Stanwood City Council Regular Meeting

SUBJECT: Change Order #7 with SRV Construction on the Viking Way project

**90TH AVE NW EXTENSION
CONTRACT #2020-29
FEDERAL AID #STPUS-9311(001)
CONTRACT CHANGE ORDER #07 – Design Change #8 Inefficiencies**

Drawing No. DR3

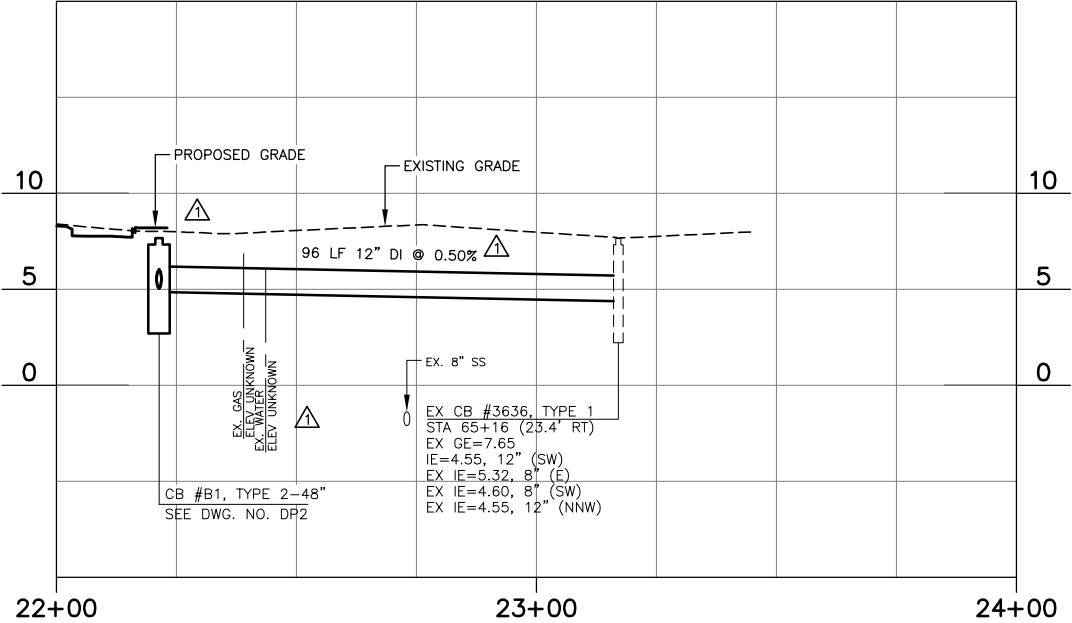
Plan sheets per Design Change #6 shows Drainage installations. The highlighted runs on the attached sheet DR3 could not be placed per plan due to conflicts shown in the table under section 1.

CITY OF STANWOOD		Drawing No.
90TH AVENUE NW EXTENSION STA 14+75 TO E.O.P.		DR3
DRAINAGE PLAN		Sheet No. 28 of 57

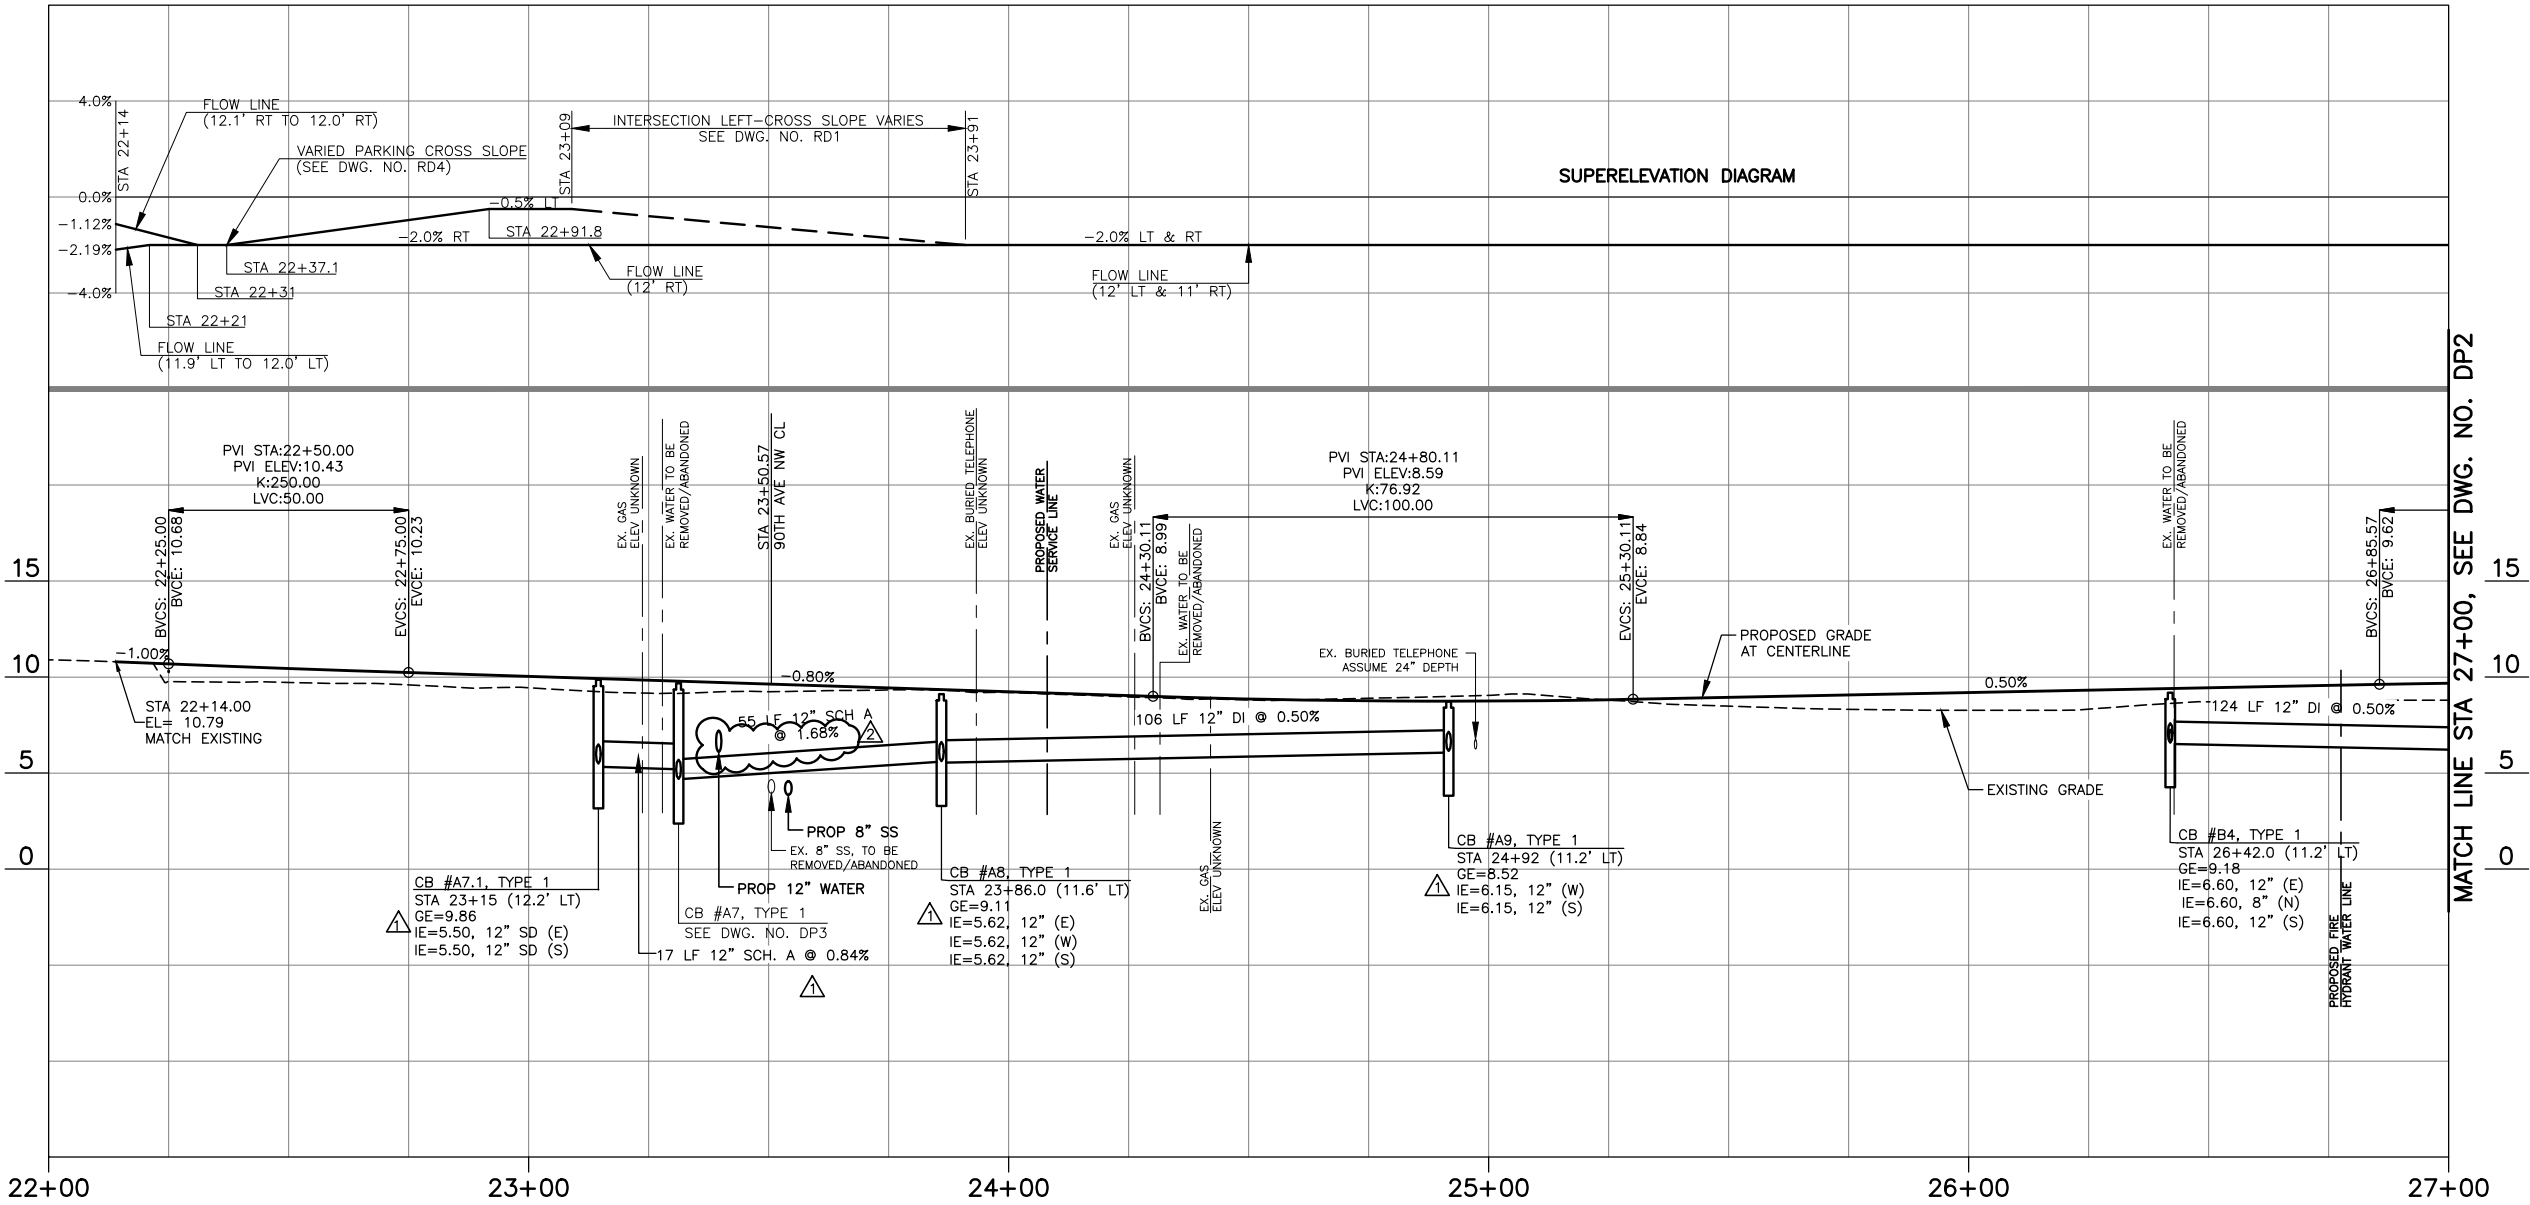
See attached drawings for revisions to the storm sewer on 90th Ave NW at 271st ST NW. A change order is to follow to incorporate additional materials for storm sewer and water main work on 271st ST NW. Water main adjustments on 271st ST SW to be tracked under time and materials.

Background: On June 25th, while placing the new water main on 90th Ave NW it was discovered that the fiber duct bank at 271st ST NW dives and impacts the placement of the storm sewer per Design Change #6. Pot holing occurred on Thursday July 2 to verify new location for storm sewer placement to cross fiber duct bank.
